Access Compliance Report

Public Rights-of-Way

(Curb Ramps)

Intersection ID: 7694	Main Street: LOG_CABIN_RD	Cross Street: THORNWOOD_RD	Location:	S
ADA ID: 5F95936AE5A5	Ramp Type: Perp	Initial Pass/Fail: Fail	Overall Compliance: No	Severity Score: 1.25
Codes/Mitigation Info/Possible Solution		Field Measurements/Component Compliance

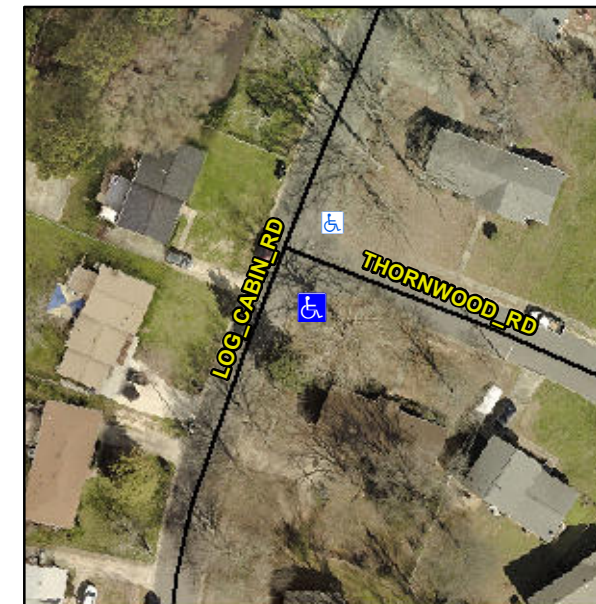
Not Found, R304.5.3

Compliance	Description	Data	Compliance	Description	Data
N/A	Ramp Length (in)	24.5	Yes	Ramp Slope (%)	7.2
Yes	Ramp Width (in)	48.0	No	Ramp XSlope (%)	2.6
N/A	Flare Type LT	N/A	N/A	Flare Type RT	N/A
N/A	Flare Slope LT (%)	N/A	N/A	Flare Slope RT (%)	N/A
N/A	Flare Traversable LT?	N/A	N/A	Flare Traversable RT?	N/A
N/A	Landing Length (in)	N/A	N/A	DWS Provided?	N/A
N/A	Landing Width (in)	N/A	N/A	DWS Contrast?	N/A
N/A	Landing Slope (%)	N/A	N/A	DWS Length (in)	N/A
N/A	Landing X Slope (%)	N/A	N/A	DWS Full Width?	N/A
N/A	Landing Curb? (Y/N)	N/A	N/A	DWS Offset (in)	N/A
N/A	Shared Landing?	N/A			
N/A	Gutter Ponding?	N/A	N/A	Gutter Slope (%)	N/A
N/A	Gutter Lip Ht (in)	0.75	N/A	Gutter X Slope (%)	N/A
N/A	Painted X Walk1?	No	N/A	Painted X Walk2?	N/A
	X Walk 1 Direction	To NE		X Walk 2 Direction	N/A
N/A	X Walk 1 Width (in)	N/A	N/A	X Walk 2 Width (in)	N/A
	X Walk 1 Slope (%)	4.5		X Walk 2 Slope (%)	N/A
	X Walk 1 X Slope (%)	0.2		X Walk 2 X Slope (%)	N/A

Remove & Replace Entire Ramp.
